ECR/Documents for Information and Approval

Giulia Romagnoli and Natalya Kahn for BE-EA, 2024-09-24

Asset Replacement Request - TT8₄ Ventilation

Protection Against Accidental Contacts for Normal Conducting Magnets in the NA

Figure 1: Installation locations.

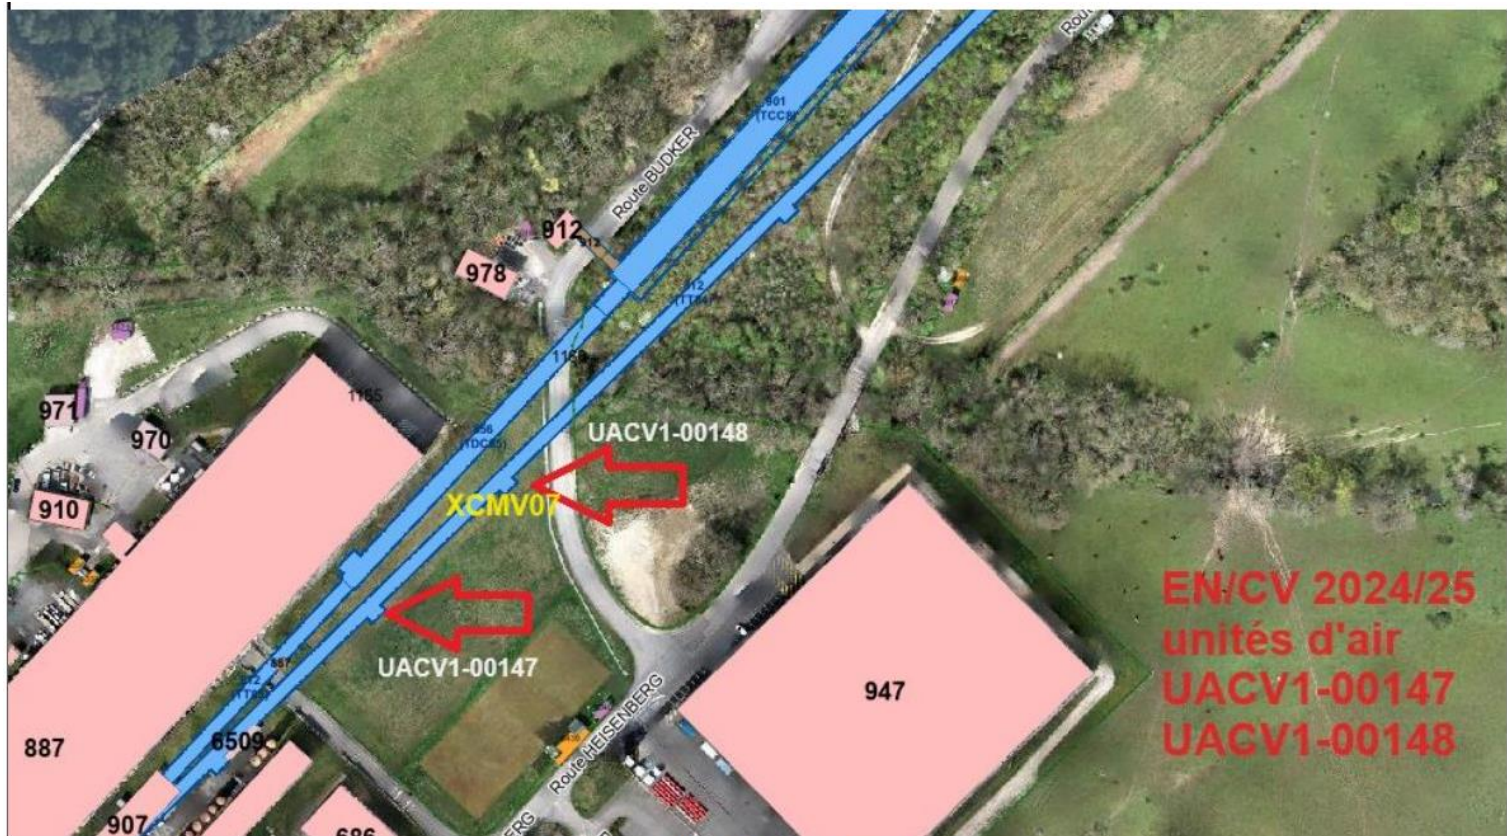
Seen by GENILLON Xavier (SY-EPC) Seen	Created on 2024-08-02, 15:58
Seen by HERTY Andreas (BE-ASR) The field SAFETY = YES ticked. No impact on EIS or other interlocked systems of the North Area identified. If impact, please specify. BE DDSO	Created on 2024-08-05, 08:38
Seen by PELLETIER Serge (EN-HE) merci de suivre les prescription du doc EDMS 2817770	Created on 2024-08-05, 11:05
Accepted with Warning by KADI Yacine (BE-EA) Could you please specify what are the RP concerns, if any, wrt the displacement and temporary storage of the magnetic collimator.	Created on 2024-08-05, 13:34
Accepted by BOISSEAUX-BOURGEOIS Philippe (BE-EA) Ok for the vacuum.	Created on 2024-08-06, 10:44
Seen by BERTONE Caterina (EN-HE) We really need to know how these cubicles look like (size, dimensions, center of gravity) and to check if the new are different from the old ones. Just to check if we have everything that is necessary for handling or we need something else. As usual, we ask that construction drawings are sent to HE before drawing acceptance to the supplier to ensure installability.	Created on 2024-08-07, 16:49

Accepted by BALTASAR DOS SANTOS PEDROSA Fernando (EN-ACE) The different steps involving other teams like transport, vacuum of secondary lines (one vacuum chamber removal), collimators team (it will have to be moved laterally to allow access), ..., was done and different steps agreed. The planning has been agreed with the NA-CONS coordination team for the YETS2024-25 (Xavier Palle)	Created on 2024-08-09, 09:31
Seen by GRECARD Jean-Louis (SY-STI)	Created on 2024-08-09, 09:52
Seen by EBN RAHMOUN Aboubakr (BE-EA) Ok for me.	Created on 2024-08-09, 10:04

Seen by VAXELAIRE Didier (EN-AA) Created on 2024-08-09, 10:42
Accepted with Warning by LAZZARONI Michael (BE-EA) Created on 2024-08-09, 10:52 Thanks for the document. Do you have a 3D model (simplified) of it? I guess that you stay in the same volume that the present installation? if not we have to analyse it in ICEA meeting. thanks.
Accepted by ABERLE Frederic Lionel (HSE-RP) Created on 2024-08-13, 17:08 OK for RP. To answer Yacine's comment: the collimator will probably be slightly radioactive (I expect it to be in the order of a few uSv/h approximately). In my opinion, storage can be done in one of the radioactive storages at Preveessin, or temporarily in EHN2, or EHN1, or in the tunnel.
Accepted by PIRA Yann Pierre (HSE-RP) Created on 2024-08-14, 10:52 OK for me. I agree with Frederic Aberle.
Accepted by JENA Helmut (EN-CV) Created on 2024-08-14, 11:25 Reply concerning your comments (thanks to you all for collaboration): - Transport and handling of the racks done by Cern transport only (not done by contractor). - RP gives green light. Slight radiation only, no need even for protection drape. - Obsolete racks will be measured and temporarily stocked and disassembled in TDC85 (as the last years). - The new power racks have the same size as the old ones (no dedicated 3D model available) Thank you!!

Seen by VENDEUVRE Camille (BE-GM) Created on 2024-08-20, 15:12
Seen by BEYNEL Alexandre (BE-GM) Created on 2024-08-26, 09:13
Seen by TSHILUMBA David (HSE-OHS) Created on 2024-08-27, 15:54 Seen. No remarks on mechanical safety. Possible further remarks from Jean-Paul Jullien for HSE-OHS.
Seen by RIOS RUBIRAS Oriol (HSE-OHS) Created on 2024-08-30, 09:08 would new units allow for interlock with Fire Detection?

The new rack is only to provide power for the ventilation unit.

The control for all the ventilation systems is done by the control cubicle in BA81 (at the surface) and is there where we would need to have the signals coming from the fire detection central and from where we can interlock the dedicated ventilation units.

Nevertheless, there are few spare wires in the underground power racks (connected to the surface control cubicle) for spare signals (e.g. new fire dampers).

Figure 4 – 3D scan and study for prototyping of QNL magnets.

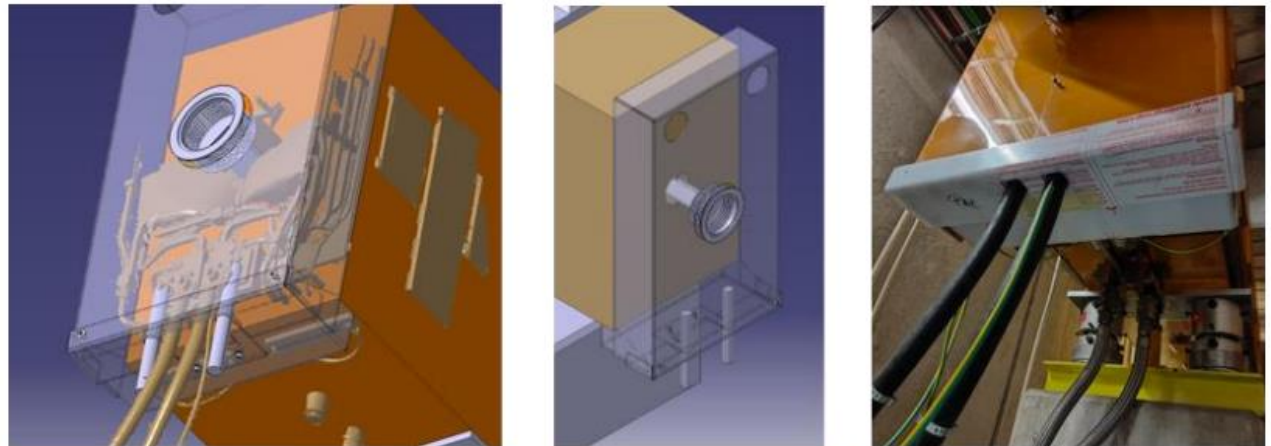
⚠ Accepted with Warning by VENDEUVRE Camille (BE-GM) Covers should not interfere with alignment system or survey reference points. The survey GIMSA are not visible on the drawings of QNL and QWL covers so it is difficult to estimate if there is interferences. The covers should be installed as low as possible in term of height so that the visibility of the sockets above the magnets is not affected.	Created on 2024-08-26, 09:17
➡ Seen by PELLETIER Serge (EN-HE)	Created on 2024-08-26, 10:37
➡ Seen by FUMEY Sylvain (EN-HE) ok	Created on 2024-08-27, 09:55
➡ Seen by FUMEY Sylvain (EN-HE) ok	Created on 2024-08-27, 10:05
➡ Seen by FUMEY Sylvain (EN-HE) ok	Created on 2024-08-27, 10:53

- I understand from a comment in v. 0.1 that, for the North Area, it was decided to apply this consolidation irrespective of the electrical safety category (a to e) of the magnet; still, for completeness, add in 3.1 the category for the four concerned magnet types (QNL, QWL, MBNH and MBNV); if such a classification is not possible at the level of the type, because of slot dependent customizations, then add a column in Tables 1-3 with the category

- discussions are ongoing about a possible reorganization of the MSC workshop in B180 (180/R-U03); this might have an impact on this activity, meaning that installation of some of the covers might be delayed after YETS 24-25

Thanks for the nice document. Probably it was already discussed, but the covers shall be removable for polarity checks in cases where there would not be any other way to access with the probe.

The new covers do not interfere with the alignment system. The geometry is contained within the existing envelope as shown in SPSMUQBT0211 and SPSMUQBT0217 reference assembly drawings, § 3.2 component drawings.

- add in 3.1 the category for the four types of magnets concerned (QNL, QWL, MBNH and MBNV); Yes it will be done.

- reorganization of the MSC workshop in B180
Production will not be affected. The production plan has been adjusted to be completed before the start of relocation activities.

Polarities are verified by MSC from the non-connection side, the side without covers which is practically accessible in all cases. If the polarities need to be checked from the connection side, the covers are easily removable, as is currently the case.

Figure 10: Relief view of the extension (Salève side).

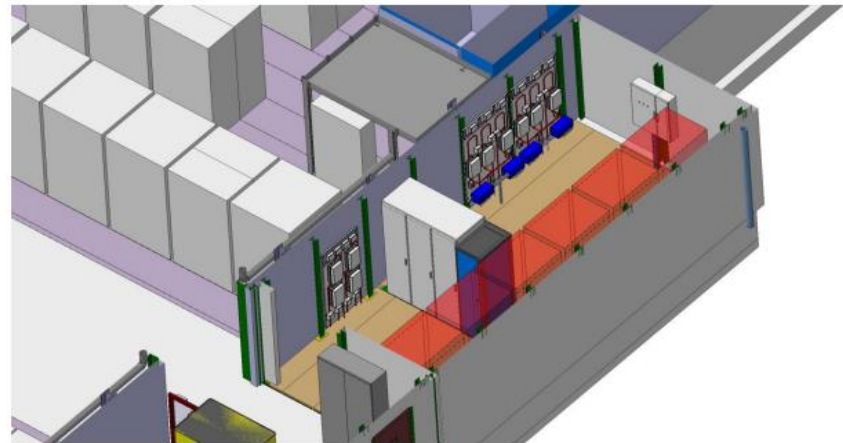
The ECR should include the ventilation required for the room (solution and costs). Should also be included that a door will be installed. The schedule must be updated (to october or so, when the racks are installed).

The dates for the implementation (06-08/2024) are outdated and need to be updated.

False floor proposal shall be reviewed by HSE (R. Morton) to guarantee stability in case floor tiles are removed for work purposes and to validate the load capacity for passing equipment for installation (e.g. racks). Indication of load capacity might be appropriate.

It is not clear if the extension will be a new part of bldg BA81 or if a new building number will be issued.

This document comes very late and after the construction of the extension ! this is rather unfortunate situation as there are quite a few open questions/issues which have been raised by colleagues and remain unanswered and not addressed by the concerned groups. A non-conformity report should be created to address these issues:

1. non-conformity of the civil engineering: floor is 70 mm higher than originally prescribed
2. ventilation of the room is not addressed
3. problem with installation of the Fire Detection Control racks as a result of the non-conformity from C.E.
4. concerns raised by HSE-RP regarding potential leaks of radioactive air.
